**Design Response Conference #9
1/04/2010**

PRESENTATION AGENDA

2. West Elevations:

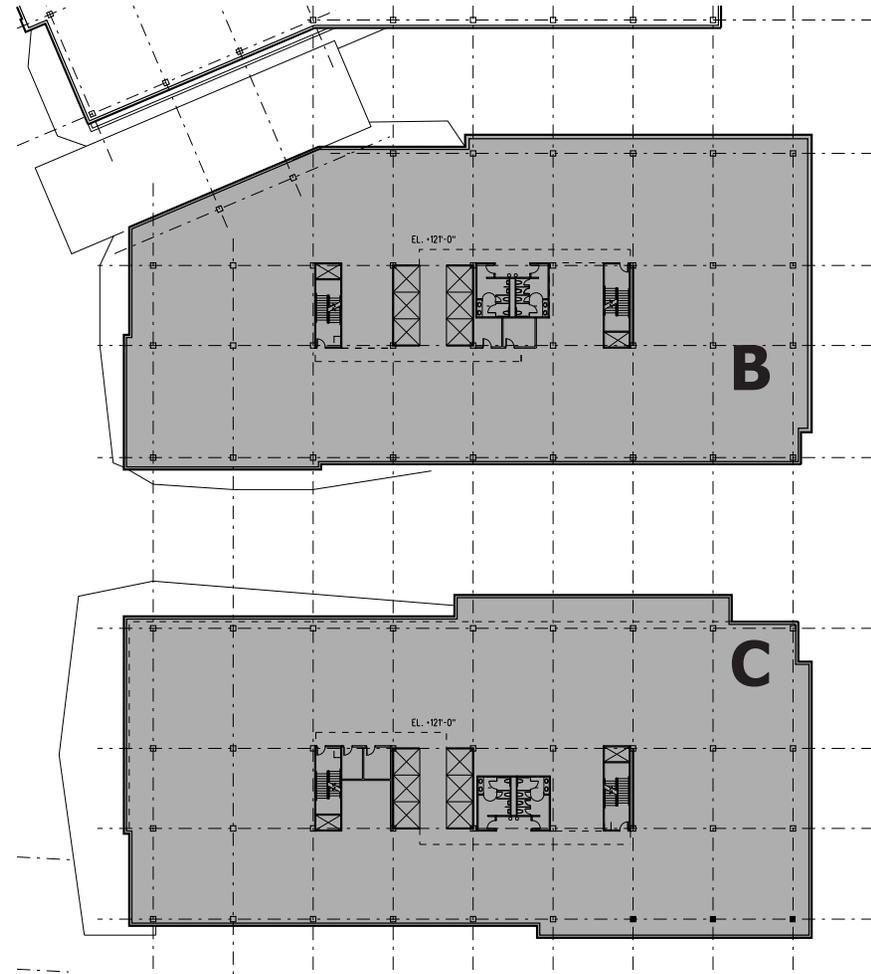
1. Space between Buildings 'B' and 'C':
 - a. Development Standards require 66' street width, while building faces are shown 49' apart. This creates deep cantilevers/colonnades and compromises the quality of the street experience. This needs to be resolved.
 - b. The portal to the site could be improved by raising the soffits at cantilevers and colonnade.
 - c. The massing of the buildings should open up to the plaza.
 - d. Measures should be taken to mitigate the vertical mass of the buildings.
 - e. A study of similar urban spaces would help the DRB to better visualize the proposed design.
2. South Elevation, Building 'C':
 - a. Massing concept approved pending facade articulation.
3. West Elevations:
 - a. The massing of the west elevation of Building 'B' should be broken up as suggested in design studies.
 - b. 'Gaskets' should be designed to optimize retail.

- a. The massing of the west elevation of Building 'B' has been broken up per the DRB's comment.
- b. 'Gaskets' and retail facades have been adjusted to provide more opening to the west.
